دائرة العطاءات الحكومية
Government Tenders Department

الرقم ع-4/1-29/6

التاريخ 2026/02/17

ملحق رقم (1)
العطاء المركزي رقم (2026/22) الخاص
باعداد الدراسات والتصاميم الهندسية ووثائق العطاء
لمشروع حلبة السباق - مشروع مدينة عمرة/ المرحلة الأولى
الجهة المستفيدة: وزارة الأشغال العامة والإسكان

Amra Race Track

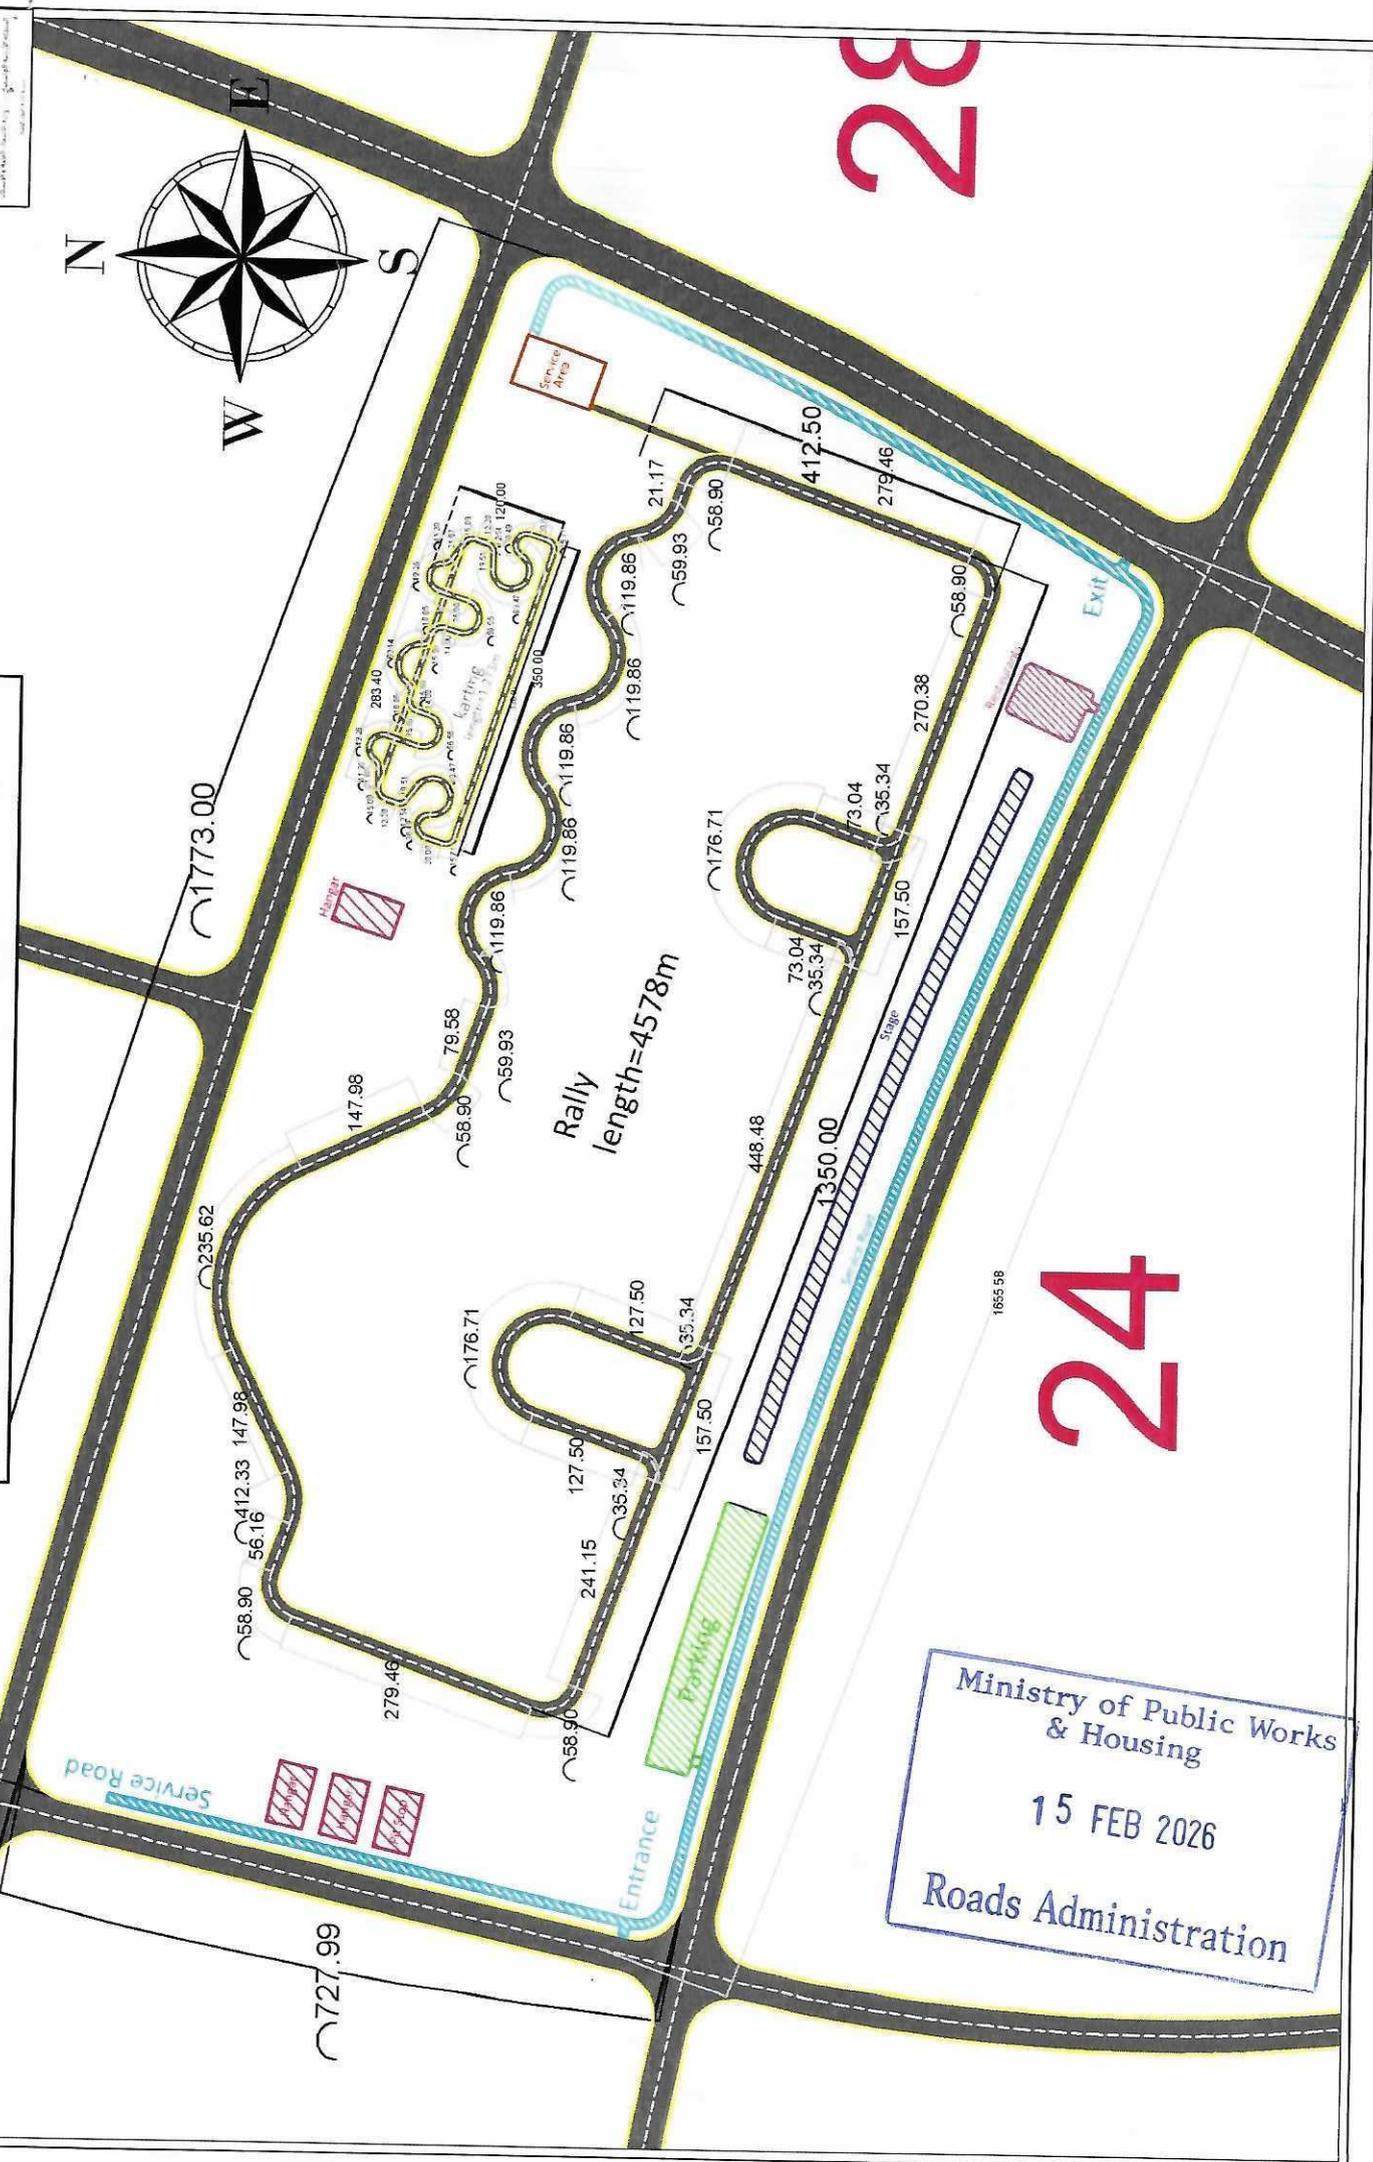
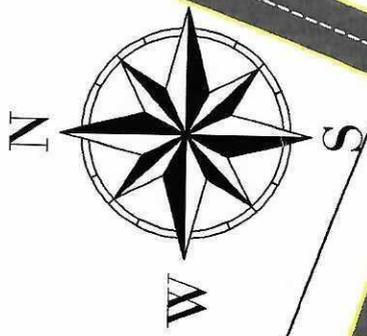
الرقم	الاستفسار	الرد على الاستفسار
1	With reference to Page 38 (third bullet point), it is mentioned that a "Concept Sketch" is provided as Annex 1 by the client. Kindly provide us with a copy of this document for our review.	Attached
2	With reference to Page 38 - 2.1 Traffic Impact Assessment and Access Studies, kindly clarify and define the designated study area for the traffic and access assessments. This should include drawings illustrating the existing and/or proposed road networks, indicating the number of lanes and their widths. In the event that new roads are proposed, please provide the relevant supporting traffic and access studies!	Abide with the Terms of Reference (ToR)
3	With reference to Page 79- Section 4.4.5: Cost Estimates & Implementation Plan, Mentioned "available budgets", Kindly clarify the amount of the available budgets, the time period they cover, and the objectives for each phase. Additionally, please provide a clear definition of the phasing approach.	Abide with the Terms of Reference (ToR)

1. مرفق طياً صفحة عدد (6) تتضمن ردود الجهة المستفيدة على طلبات الإيضاح الواردة على العطاء موضوع البحث.
2. يضاف المخطط (Amra Race Track) إلى وثائق العطاء.
3. يودع العرض (الفني) في خانة العرض الفني والعرض (المالي) في خانة العرض المالي وترفق صورة عن تأمين دخول العطاء (كفالة بنكية) من خلال نظام الشراء الإلكتروني الأردني (JONEPS) وسيتم استبعاد أي عرض يرفق العرض المالي ضمن العرض الفني) في موعد أقصاه الساعة الثانية عشرة ظهراً من يوم الإثنين الموافق 2026/03/09 بدلاً من يوم الإثنين الموافق 2026/02/23 وسيتم فتح العروض (الفنية) على نظام الشراء الإلكتروني الأردني (JONEPS) الساعة الواحدة من بعد ظهر نفس اليوم، وسيتم بث فتح العروض على موقع الدائرة على شبكة الانترنت مباشرة.
4. سيتم قبول الكفالات الصادرة بموعد إيداع العروض الأصلي.
